**REMARKS**

**Objections to the drawings**

**FIG. 2**

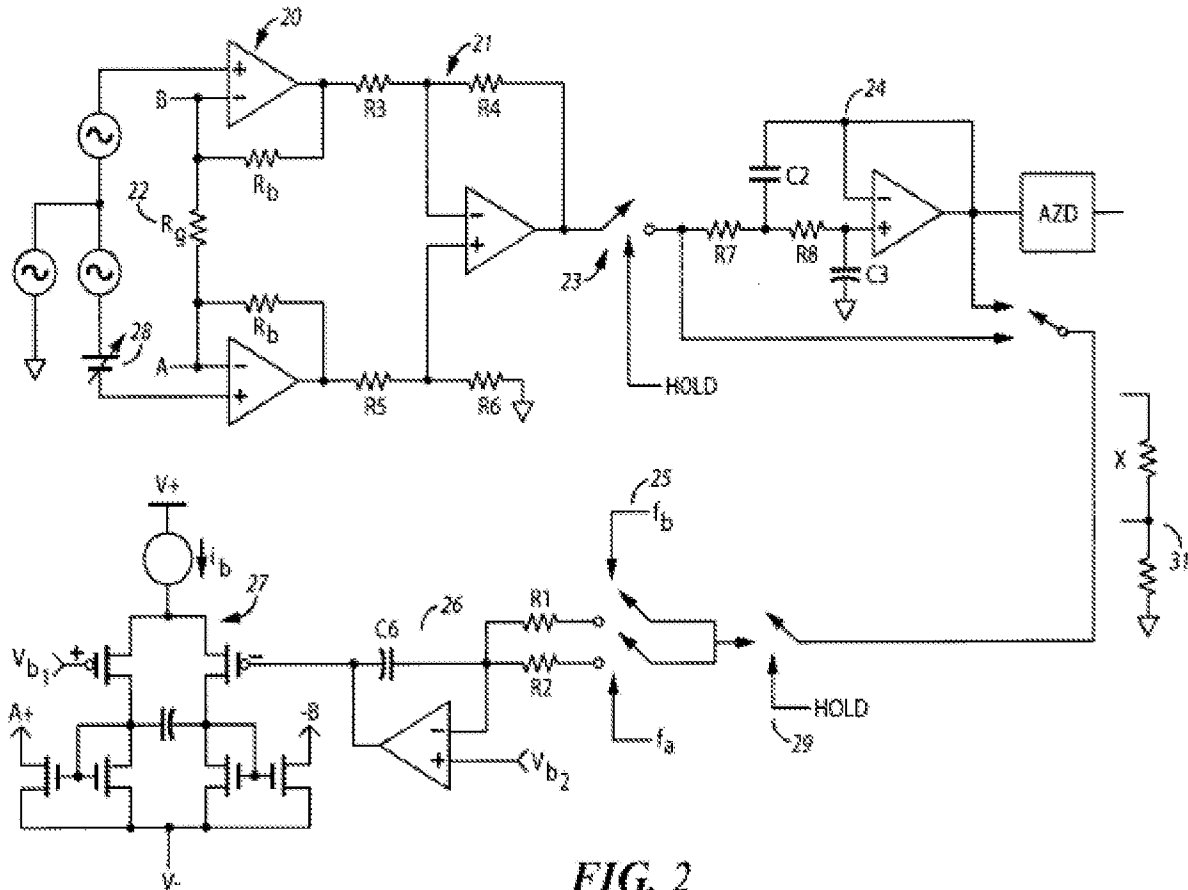
The Examiner objected to the drawings under 37 C.F.R. 1.83(a) as not showing certain elements of claim 1; in particular, “at least two signal inputs” and “a high-pass filtered version of the resultant error-corrected signal.”

Second, and again with all due respect, the applicant notes that the elements in question do, in fact, appear in the drawings. Consider for example FIG. 2 (reproduced below for the convenience of the Examiner). At the upper left this drawing clearly depicts the two signal inputs. And the gated integrator (denoted as 26 in this figure) provides the high-pass filtered version of the resultant error-corrected signal via the nodes denoted as “A” and “B” back to the front end of the differential gain stage (denoted as 20 in this figure).

Accordingly, although specific support in the drawings is not required for claim 1, we respectfully submit that such support is nevertheless present in the drawings.
